**Report on Implementation of
Remedial Action at Landfill 6 AOC**

**Former Griffiss Air Force Base
Rome, NY**

**RESPONSE TO EPA COMMENTS ON
TECHNICAL REVIEW OF THE
REPORT ON IMPLEMENTATION OF REMEDIAL ACTION AT LANDFILL 6
AUGUST 2008
FORMER GRIFFISS AIR FORCE BASE
ROME, NEW YORK**

Figure 1
Landfill 6 AOC
LTM Network

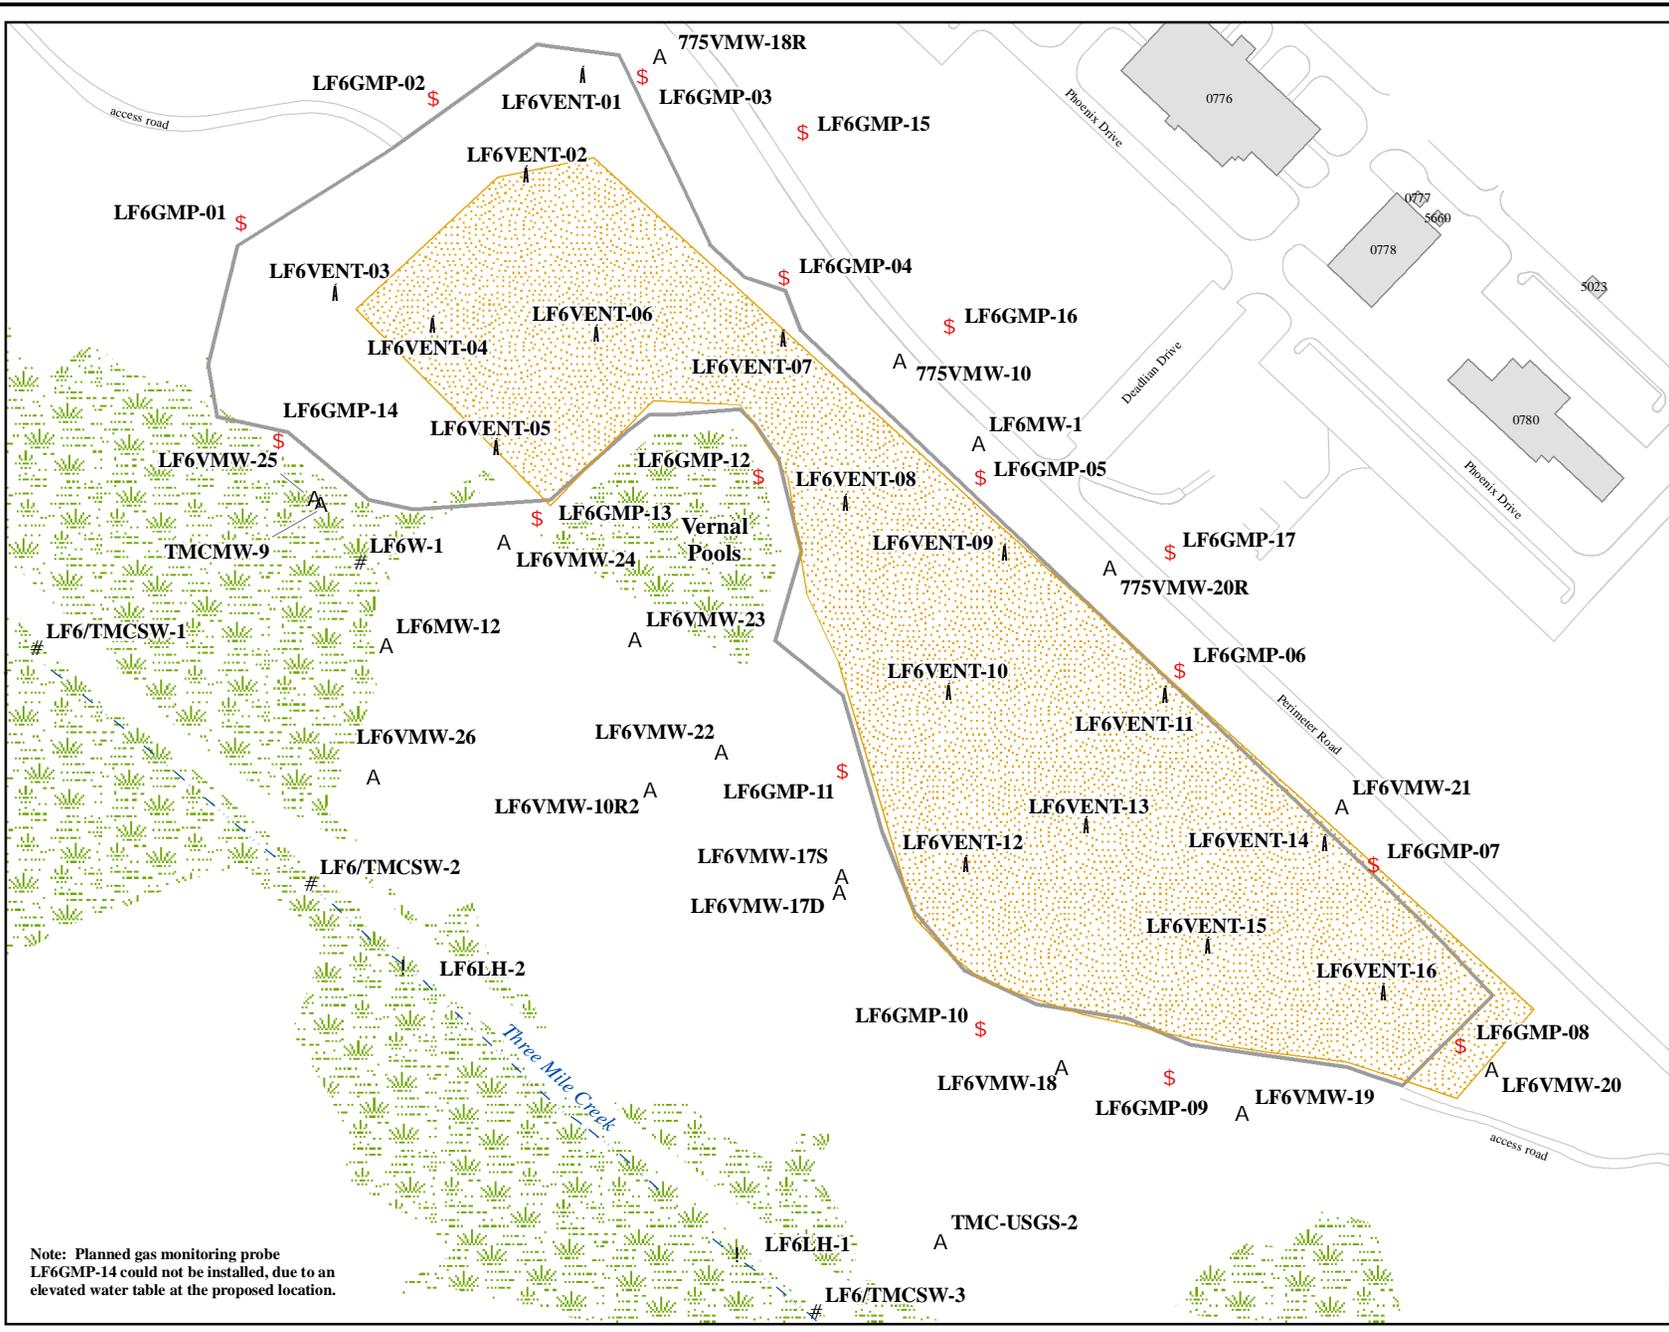
#	Page, Section	USEPA Comment	Response
ER2	Section 2.3.3.1, Additional Material Sources, Page 8 of 22	This section of the Engineers Report states that cobbles were placed in the hardfill area of the landfill. The Implementation Report addresses instances of additional materials being incorporated into the final remedy, but a drawing showing the locations where these materials were placed was not included in the Implementation Report. Please revise the Implementation Report to provide a figure showing the locations of the additional hardfill materials.	For consistency, the AFRPA recommends that the Landfill 6 Implementation Report does not get modified to include the detailed figure from the Engineer's Report (As-Built Drawing, C-2, Subgrade Plan, Appendix F).
ER3	Section 2.3.3.2, Gas Monitoring Probes, page 9 of 22	This section of the Engineers Report indicates that a total of 16 Gas Monitoring Probes were installed. Figure 1 of the Implementation Report depicts sixteen gas monitoring probes, but does not include a LF6GMP-14 location. It is my recollection that GMP-14 could not be installed due to an elevated water table. Please revise the Implementation Report to include a note on Figure 1 which addresses this inconsistency.	Figure 1 will be revised to illustrate the proposed location of LF6GMP-14. The revised figure will also incorporate the following explanation for the variance: "Planned gas monitoring probe LF6GMP-14 could not be installed, due to an elevated water table at the proposed location."

Note: Planned gas monitoring probe LF6GMP-14 could not be installed, due to an elevated water table at the proposed location.

Figure 2
Landfill 6
Land Use Restriction

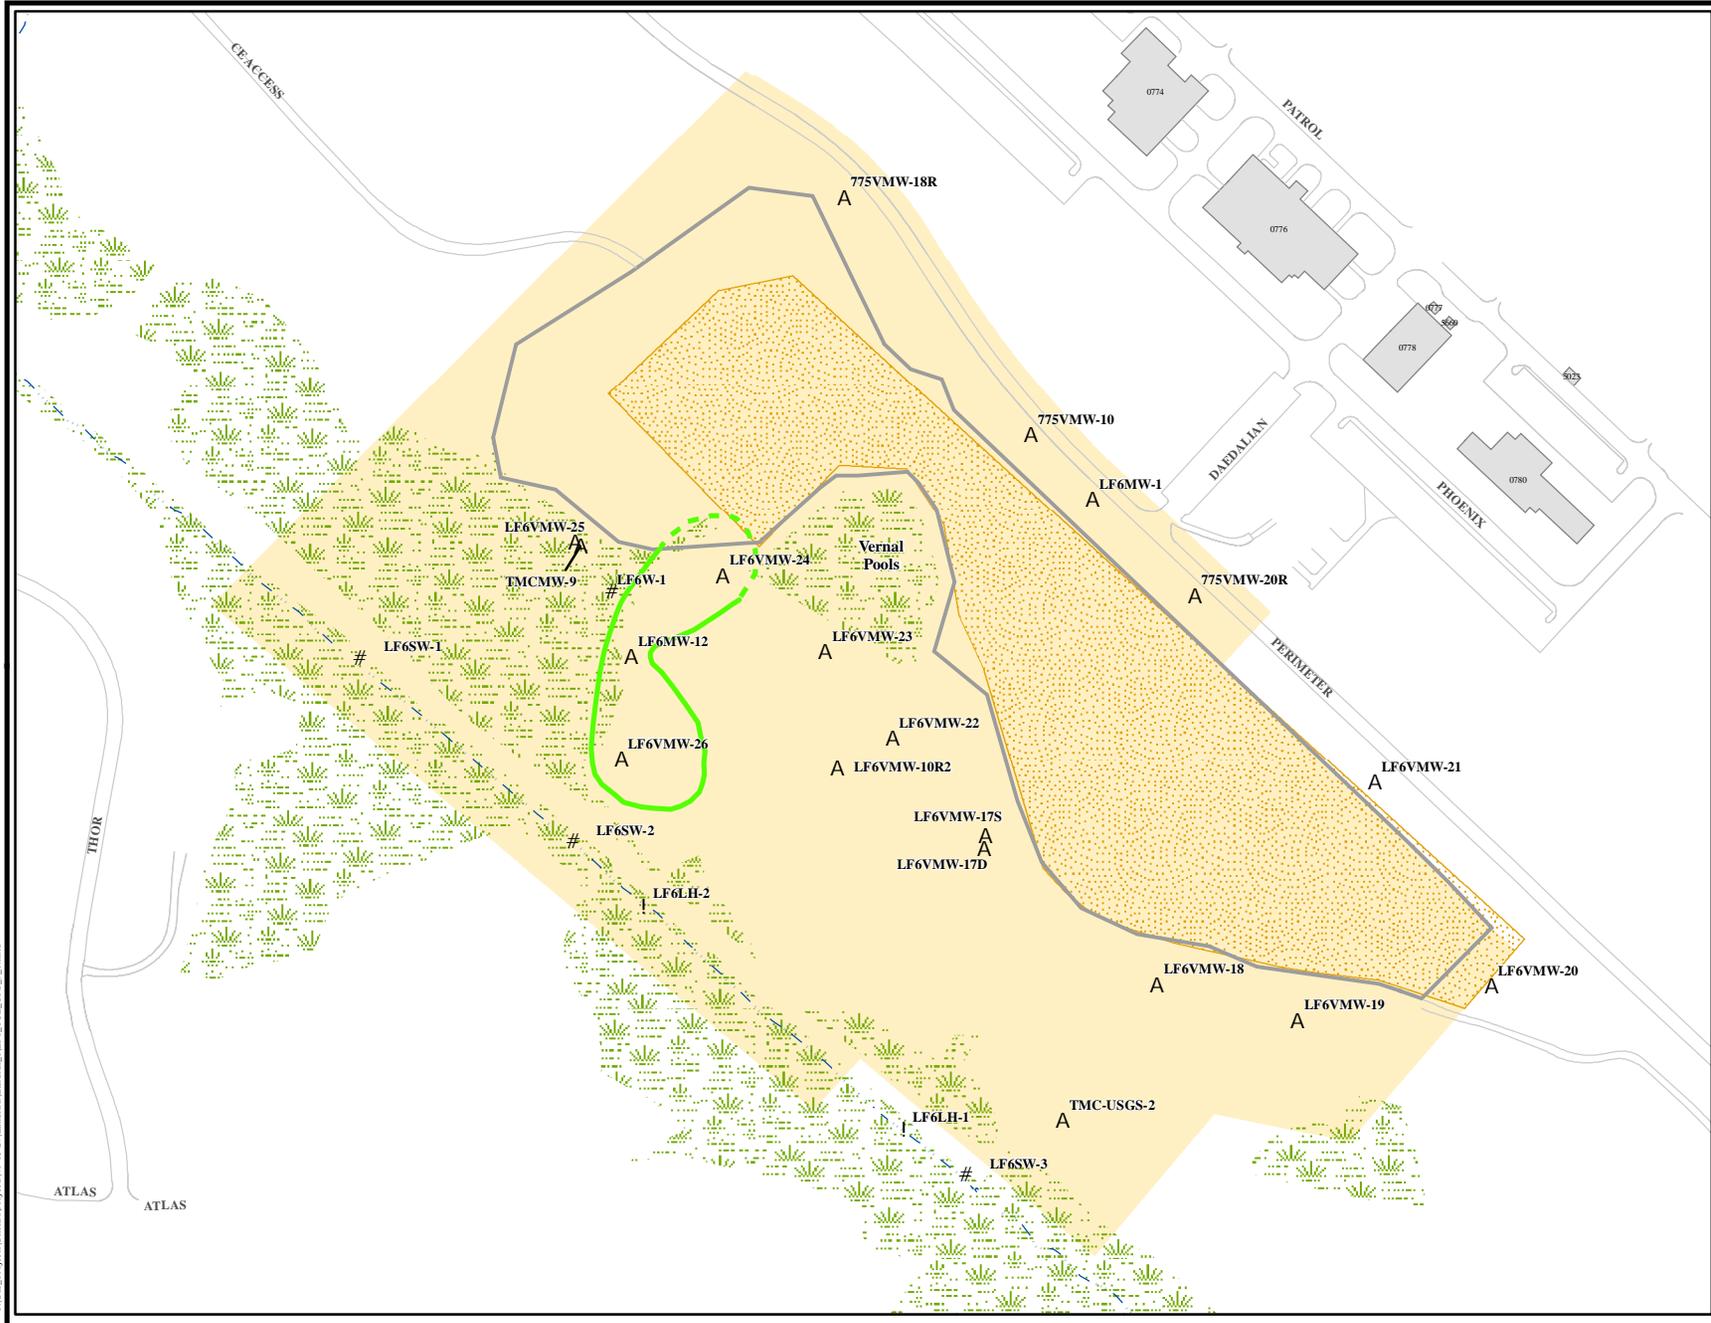
Minor Comment			
1	Section 2.2, Institutional Controls/Deed Restrictions, Page 5	The first bullet of this section refers the reader to Figure 1 to view the area which has groundwater extraction/utilization/consumption restrictions. This area is shown on Figure 2. Please revise the Implementation Report to correct this discrepancy.	The figure number will be updated.
//////////END OF COMMENTS////
